Re: **Fitch Park ASR Wells 5 & 6; Responses to RFI dated 2-15-19**

CALIFORNIA AMERICAN WATER  
**FITCH PARK ASR WELLS 5 AND 6 ABOVE GROUND FACILITIES**

DRAWING NUMBER: **M-2**

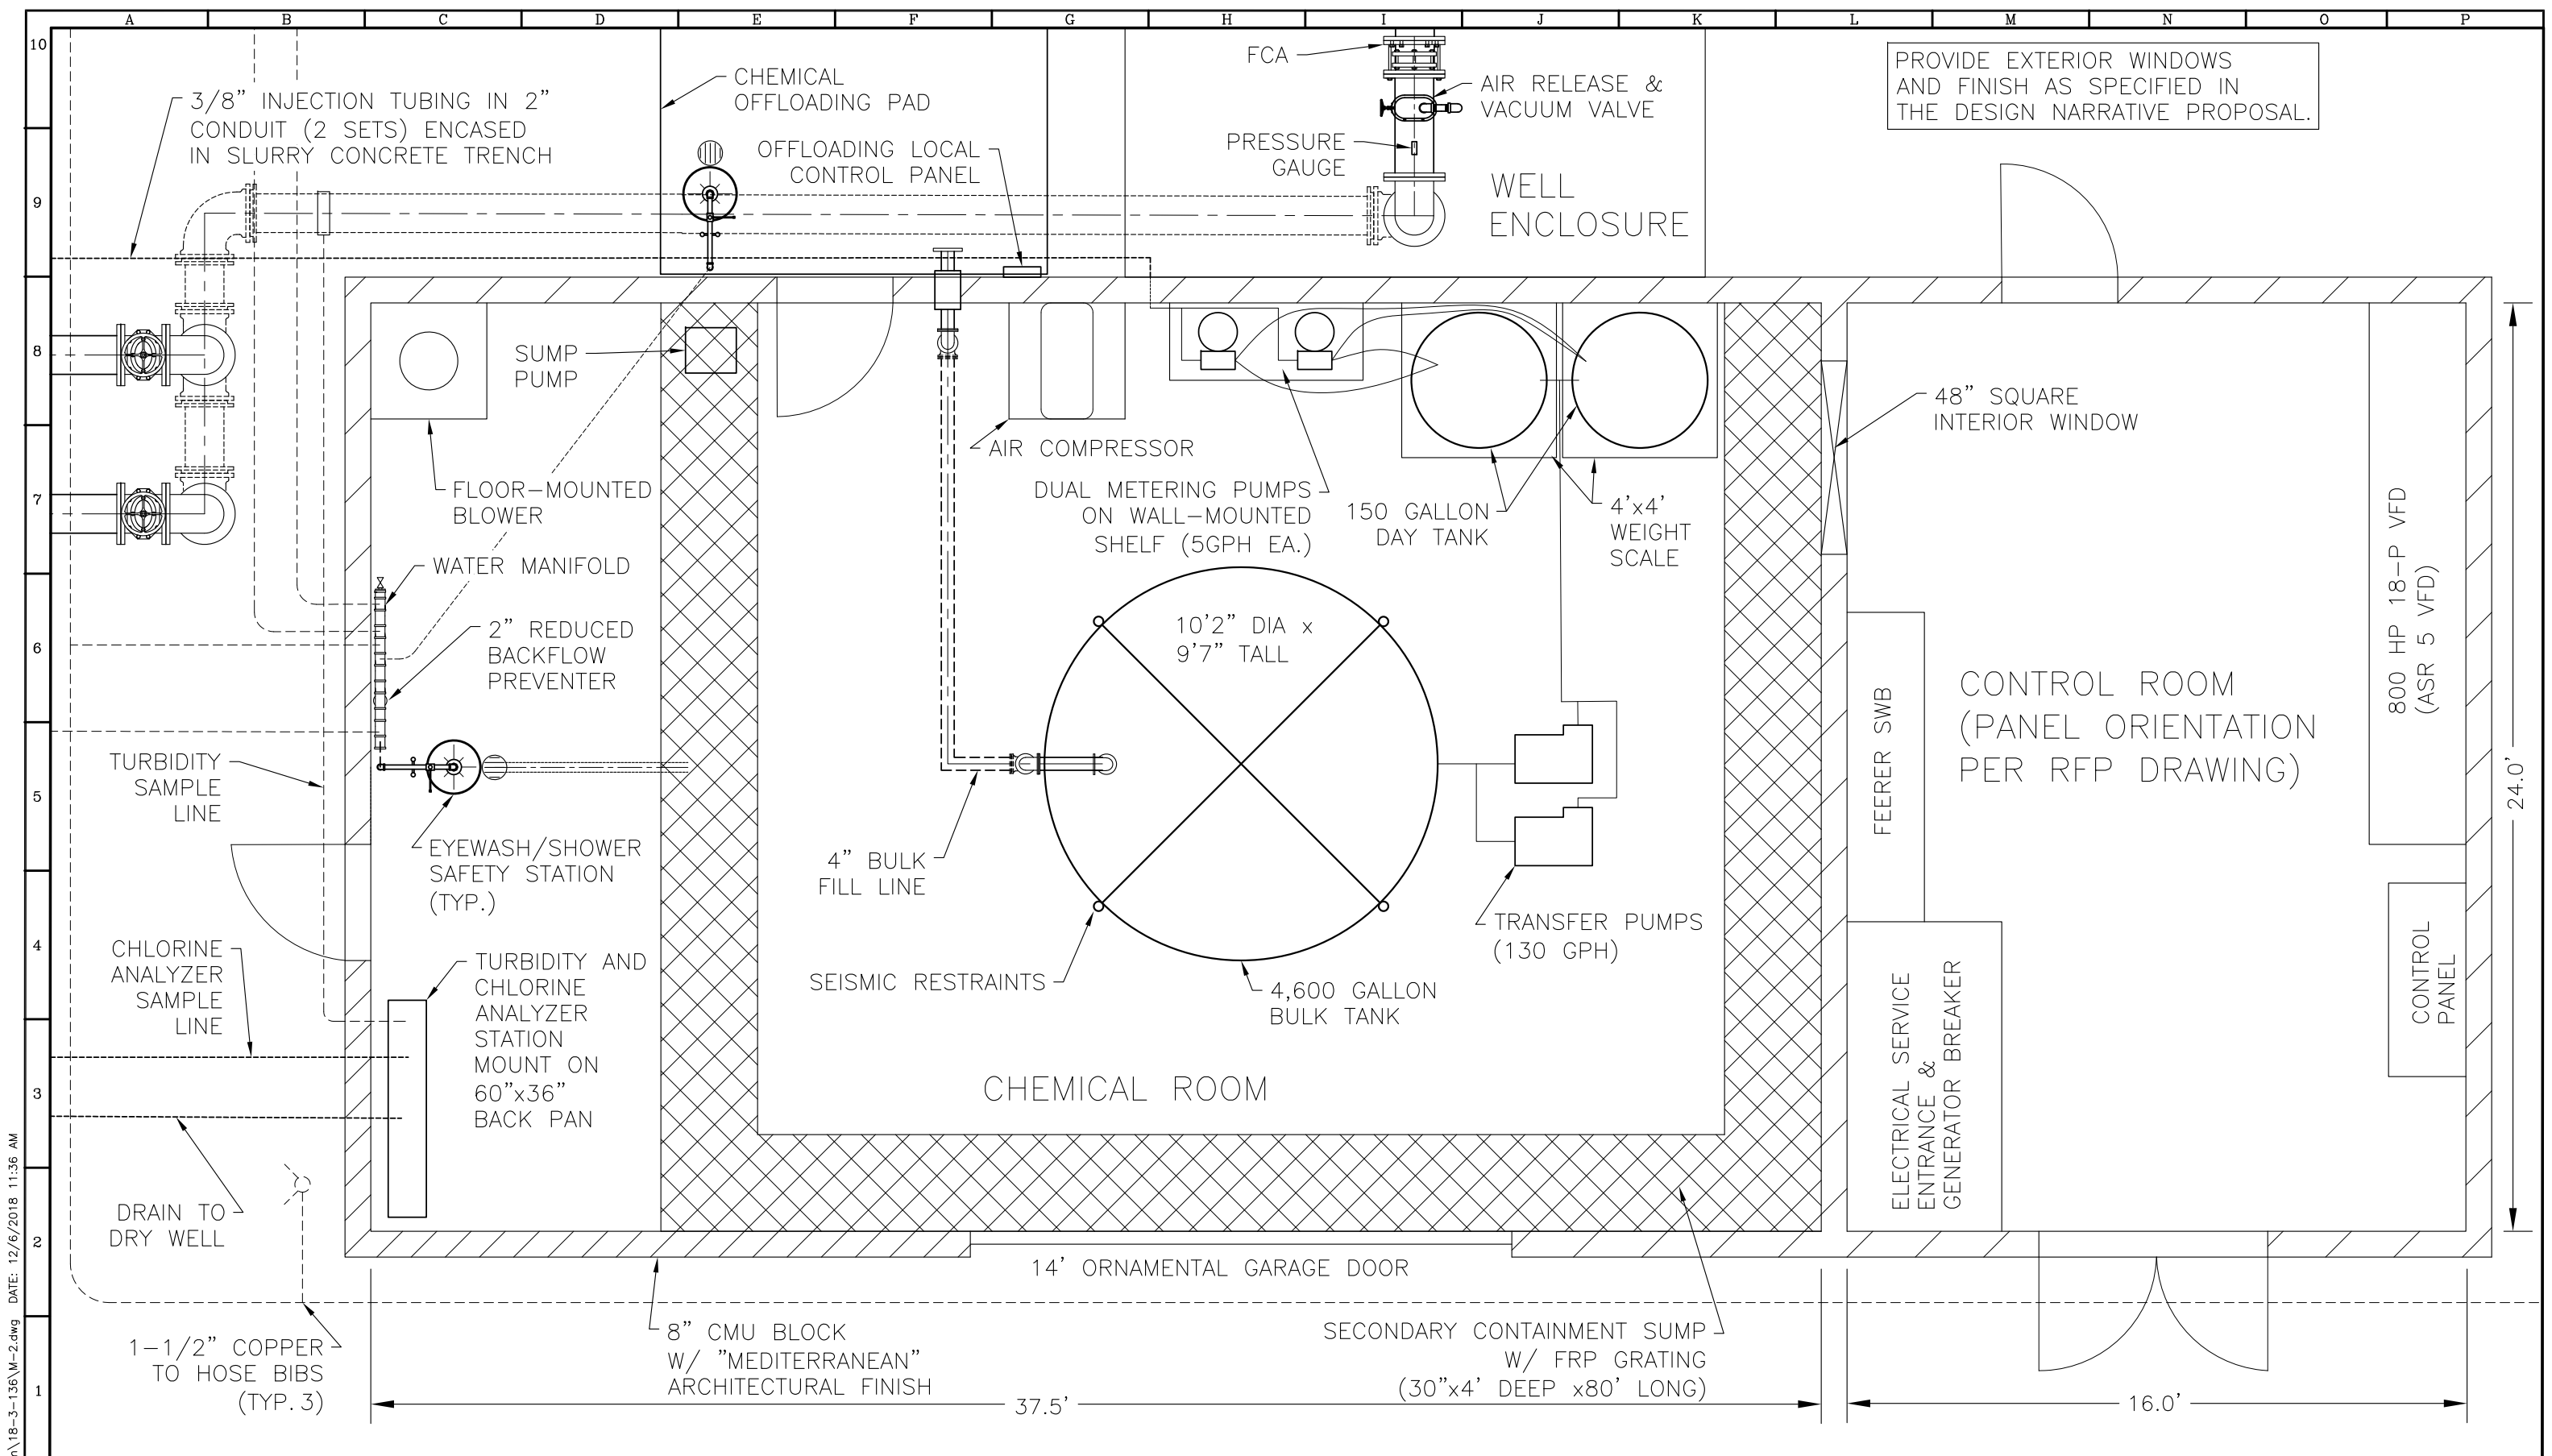
4. You requested a P&ID from our DOR (LSCE) for the Disinfection Building.

HHCI Response: Disinfection Building P&ID drawing - Drawings M-2 and P&ID I-1 are attached (Attachment 3a and 3b).
